**ARCHITECT'S ADDENDUM**

Addendum Number: 03

Transportation Center

Subject: Addendum No. 03 to the Construction Documents for the Fort Zumwalt School District Transportation Center

3 SOUTH BUILDING ELEVATION  
A5.01 1/8" = 1'-0"

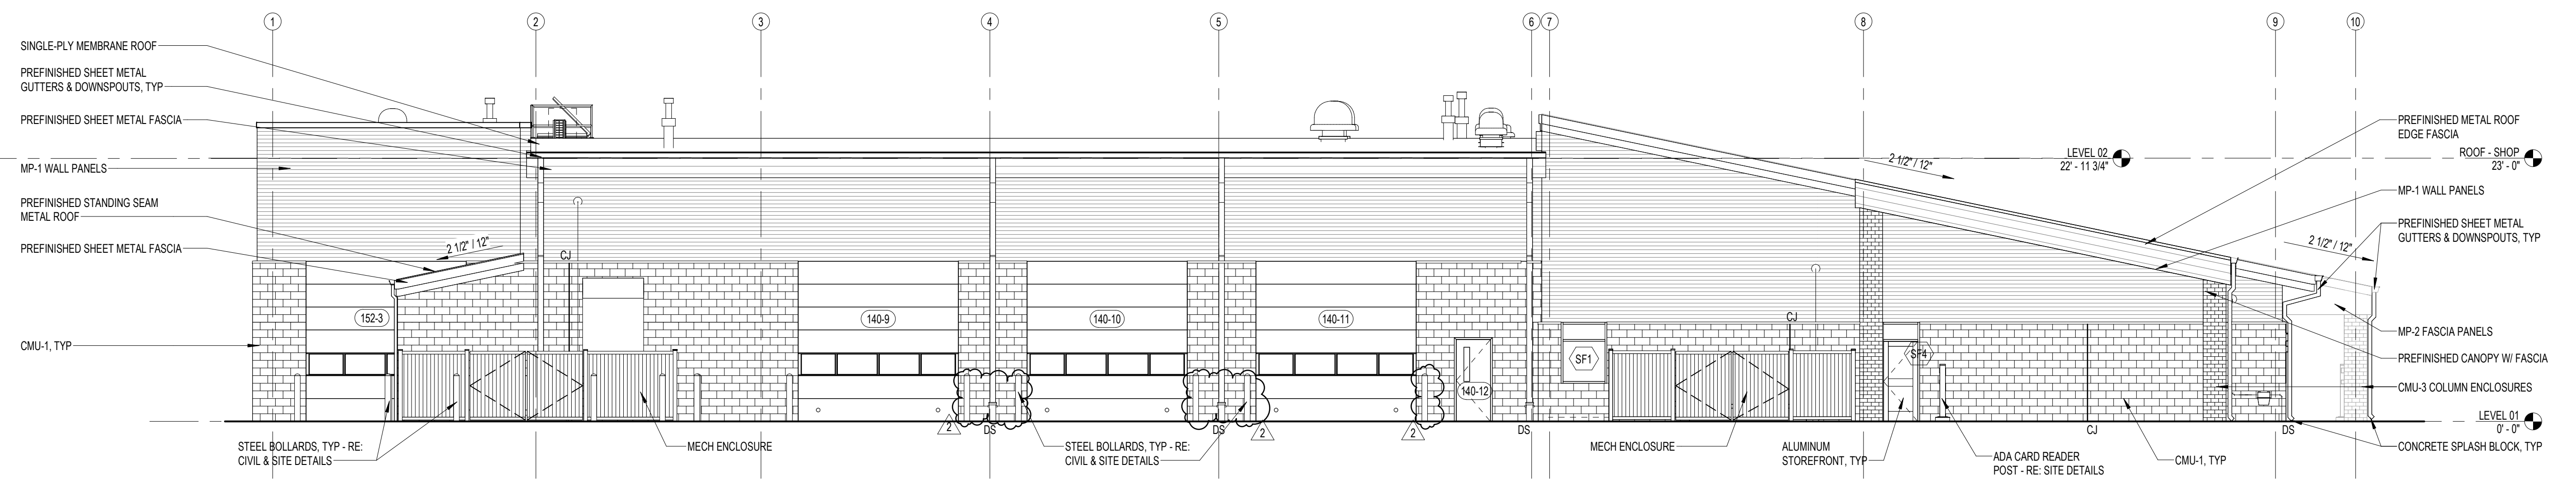
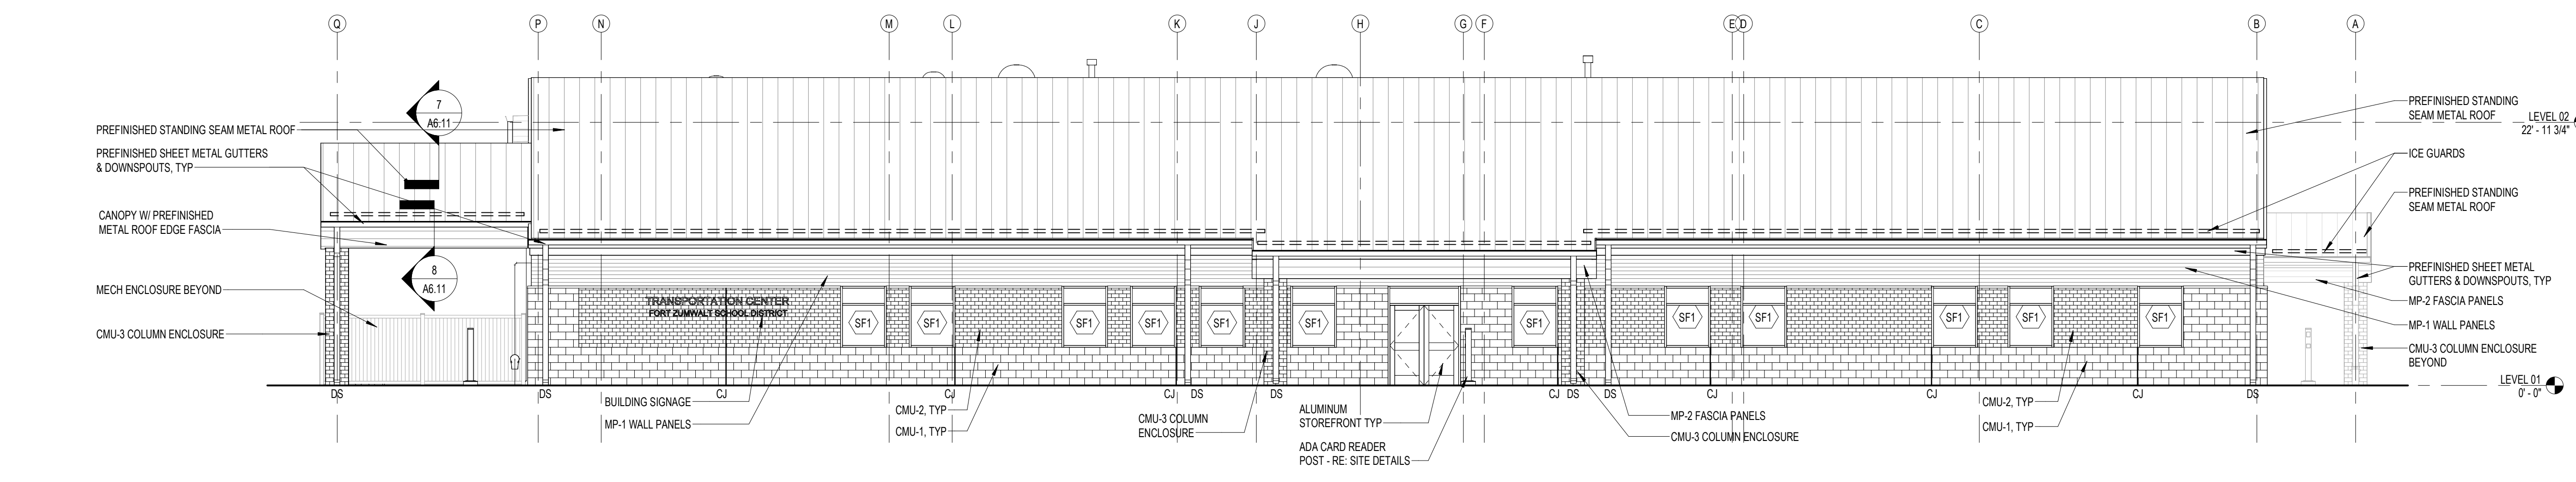
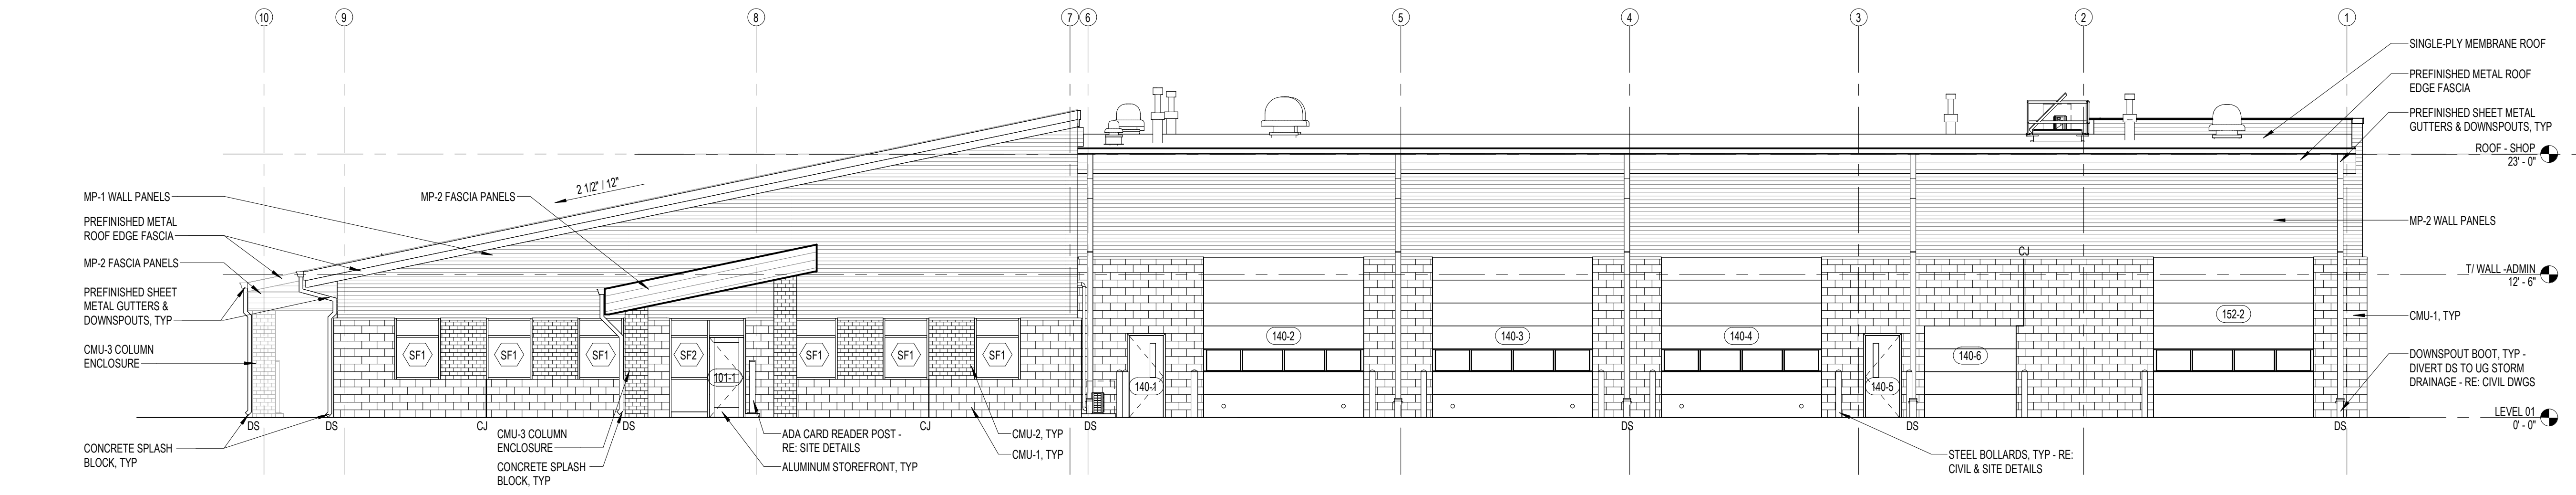
Q – The architectural floor plan and elevations do not show bollards at the (3) OH doors on the South elevation. However, there's a note on the elevations calling these out, but doesn't show the bollards. My question is, is the intent to match the bollard layout of the (3) OH doors on the North elevation? Or are bollards not required at the OH doors on the South elevation?

Q – Ref. sheet A5.01. What type of fence is the mechanical enclosure going to be. It is not in the specs.

A – *Bollards are required at both the north and south elevations. The layout at the south elevation should be the same as the north elevation. See revised sheets this addendum.*

A – *The mechanical enclosure fencing is a decorative vinyl fence as specified in section 323119.13.*

**FOUNDATION PLAN**  
1/8" = 1'-0"  
S2.01

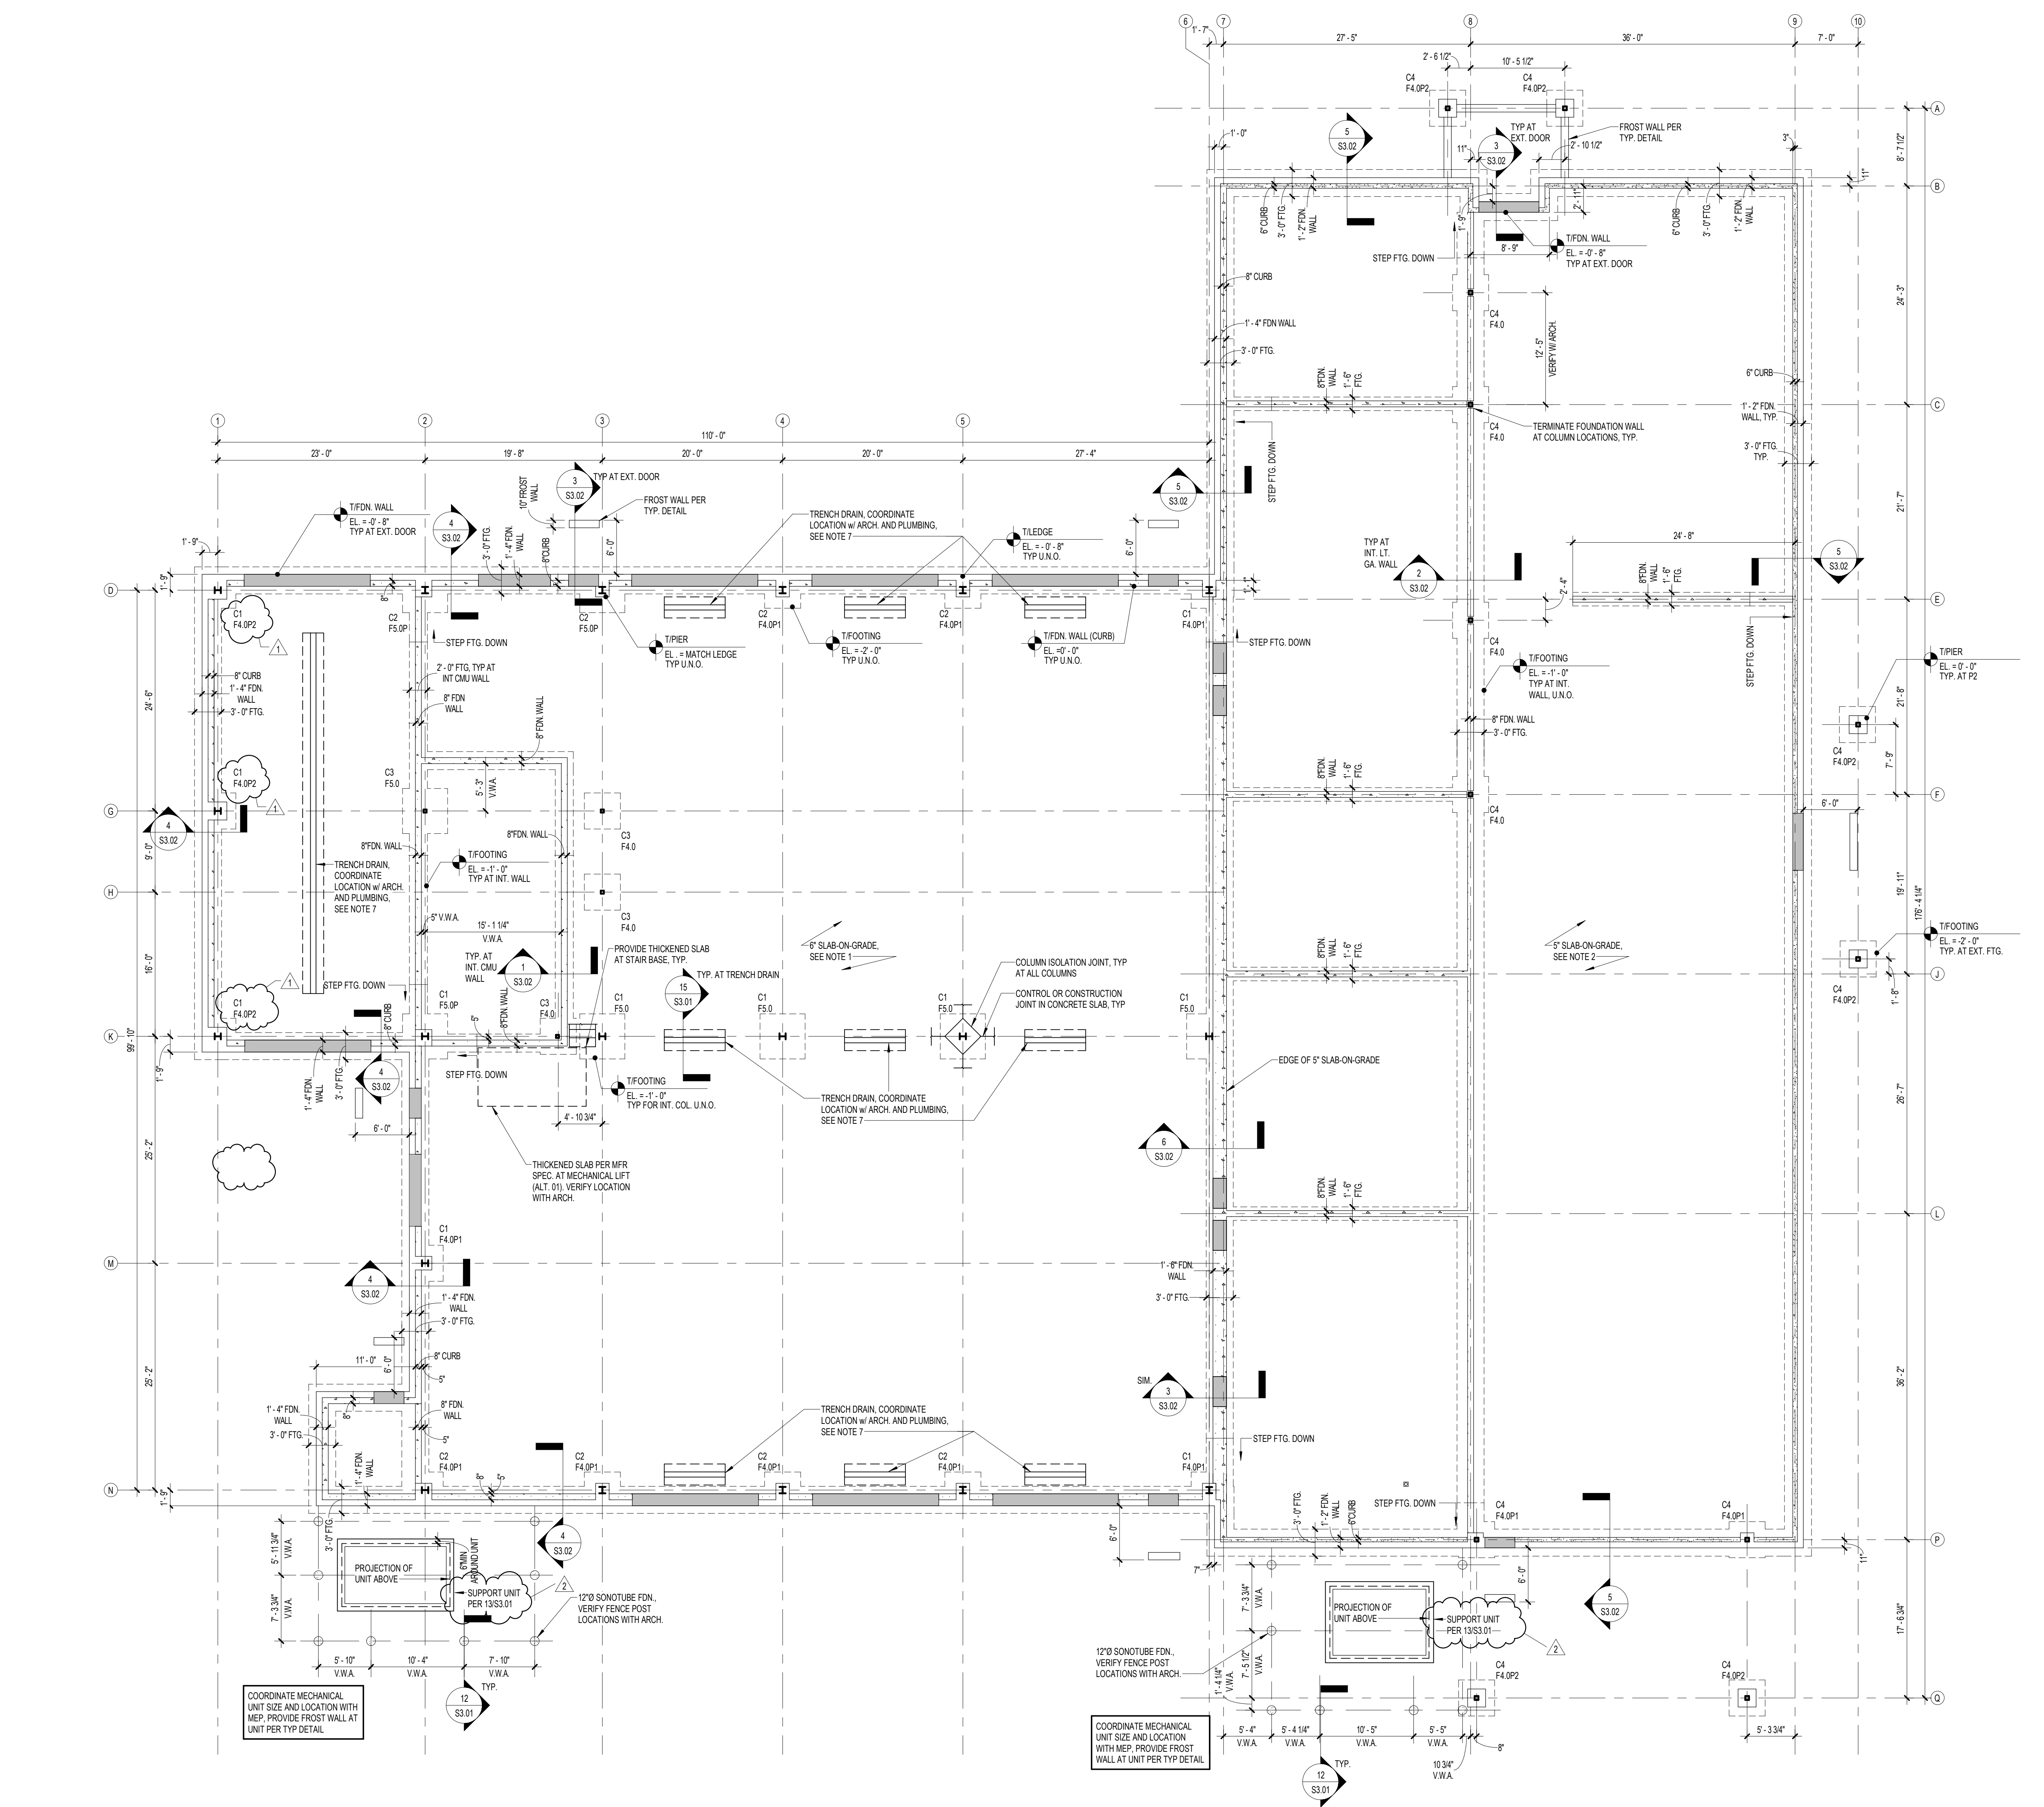
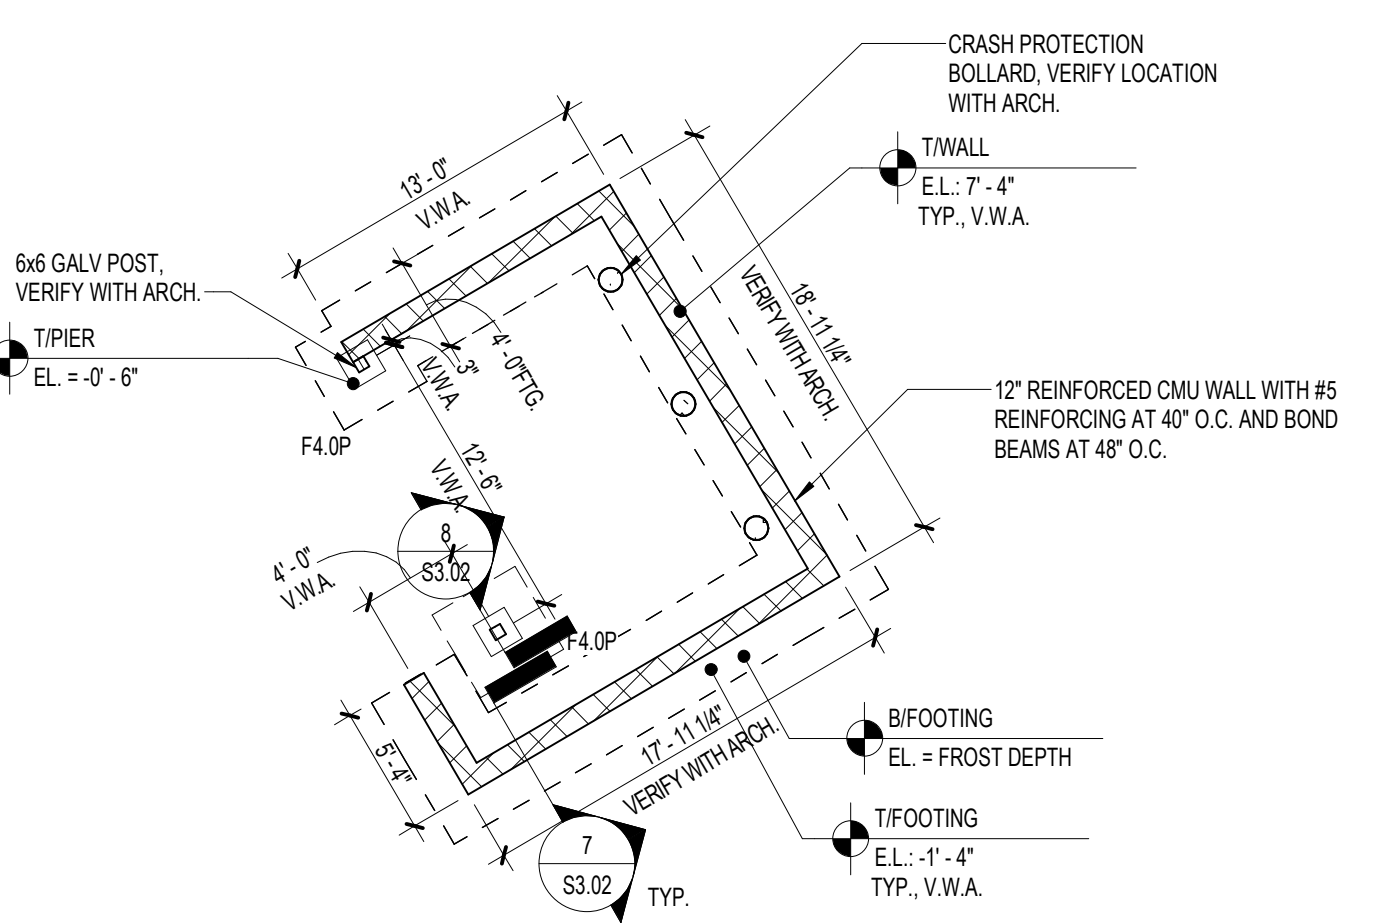
Q – On sheet S2.01 Foundation Plan note 5 states that the Geotechnical Engineer is to be retained by the contractor shouldn't this be by Owner?

9. S2.01
  - a. Revise foundation plan note 5 to read "ALL EXCAVATION, SUBGRADE PREPARATION AND BACKFILL TO PROJECT ELEVATIONS SHALL BE PERFORMED UNDER DIRECT SUPERVISION OF GEOTECHNICAL ENGINEER RETAINED BY THE OWNER, AND IBC SPECIAL INSPECTIONS SHALL BE PROVIDED PER GENERAL NOTE.
  - b. Revise detail callout at mechanical unit conc. support to 13/S3.01 in lieu of 16/S3.01

A - *Revise Foundation Plan note 5 to read "... GEOTECHNICAL ENGINEER RETAINED BY OWNER"*
